CALIFORNIA COASTAL COMMISSION

COASTAL DEVELOPMENT PERMIT APPLICATION

Application number3-01-078, Corrigan

Project descriptionDemolition of existing 832 square foot single-story residence and carport, to facilitate construction of a two-story 1,800 square foot residence and garage.

EXHIBIT NO. 3

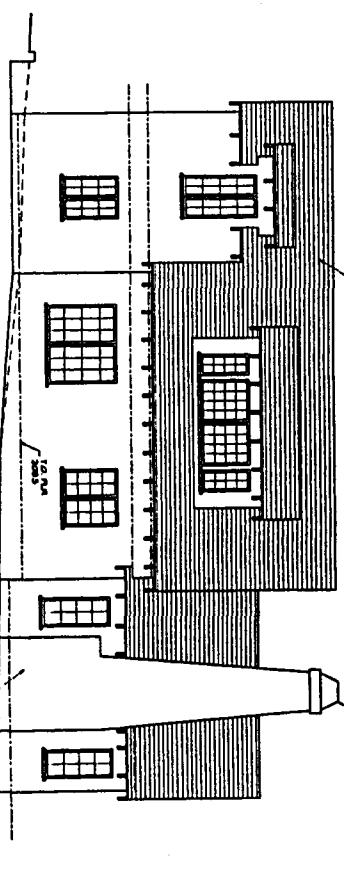
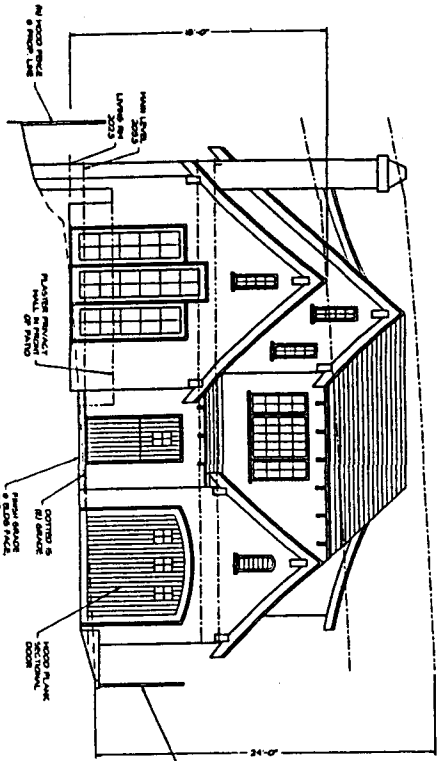
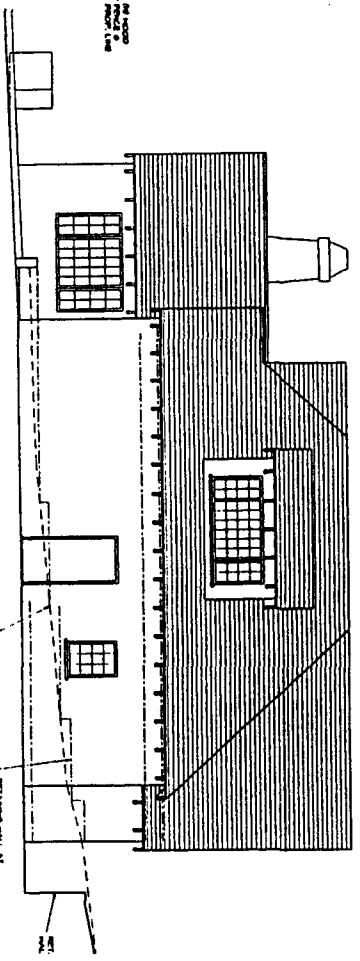
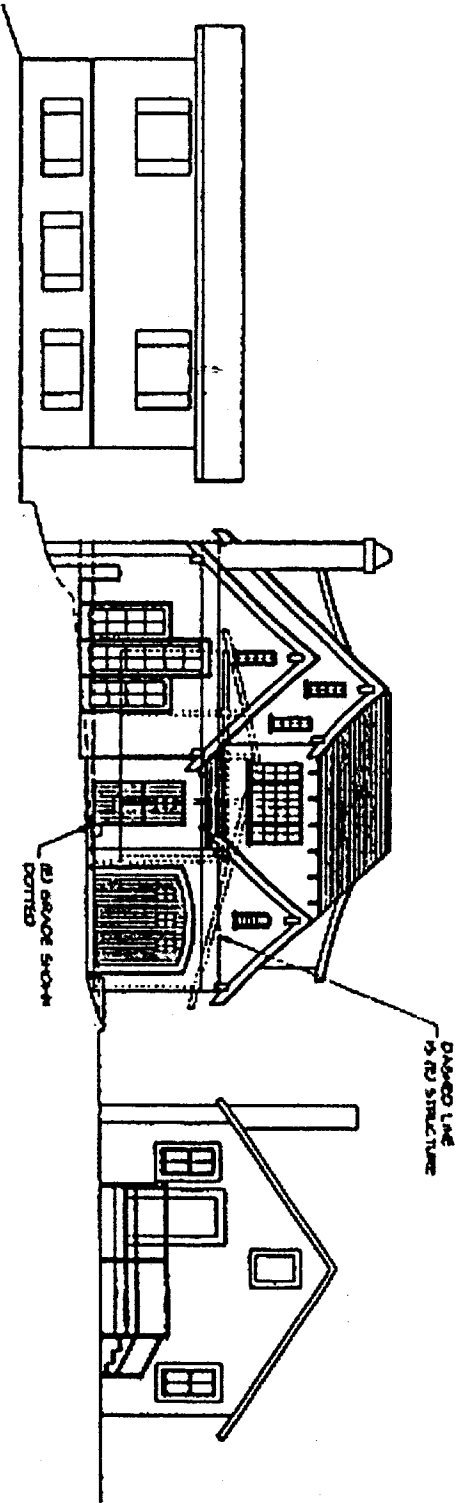
articulations to the house and roof form, because of its size, height, mass, and design, it will appear large, dominant, and generally, "boxy" from the west, Guadalupe Street, elevation. As proposed, the replacement project represents an 11% increase in site coverage and a corresponding 207% increase in mass.

Commission staff has had an opportunity to evaluate the application materials submitted for review and has similar concerns to those expressed in the findings of the City. Staff reviewed the broader context of the surroundings as well as the investigating the structures immediately adjacent to the proposed development to evaluate whether the proposed structure would deviate significantly from the character of the neighborhood. In its findings, the City described the neighborhood context as follows: "from first to Fifth Avenues there are a number of one-story residences punctuated by some two-story that front onto Guadalupe Street." The house immediately south of this site is single-story and though it rests on a slightly higher finished grade elevation, it would still be four to five feet below the roofline of the proposed project. The house immediately to the north is one and one-half stories but rests at a lower finished grade elevation. Given the raised building envelope and two-story design, the roofline of the proposed project would be between ten to eleven feet higher than the roofline of the neighboring property to the north. Accordingly, the proposed development appears much larger and dominant from Guadalupe Street and is not compatible with its immediate surroundings.

Additionally, the increase in height and square footage increase the mass of the structure dramatically. Accordingly, the additional size necessitates a reduction in the existing setbacks. This is particularly noticeable on the side yard elevations where the proposed setback is 3 feet versus existing setbacks of 11 and 12 feet, exacerbating the overly large and boxy appearance from Guadalupe Street. Thus, the new structure will appear substantially larger, "boxy" and of a distinctly different genre than the two modest cottages on either side. The proposed design does not necessarily compliment the current site conditions and may detract from them. As a result, the development will be the dominant feature of the site and will dominate the immediate surroundings of this neighborhood. See Exhibit 3.

A second alternative would be to submit an application for a structure of similar size, height, and volume as the existing structure. The design would also emphasize traditional architectural styles similar to the craftsman-type structures immediately adjacent to the subject property and seen elsewhere in the neighborhood. If a larger home is desired, a single story residence that steps-up from the front of the building envelope and back from the Guadalupe Street frontage, minimizing overall height, could also be considered.
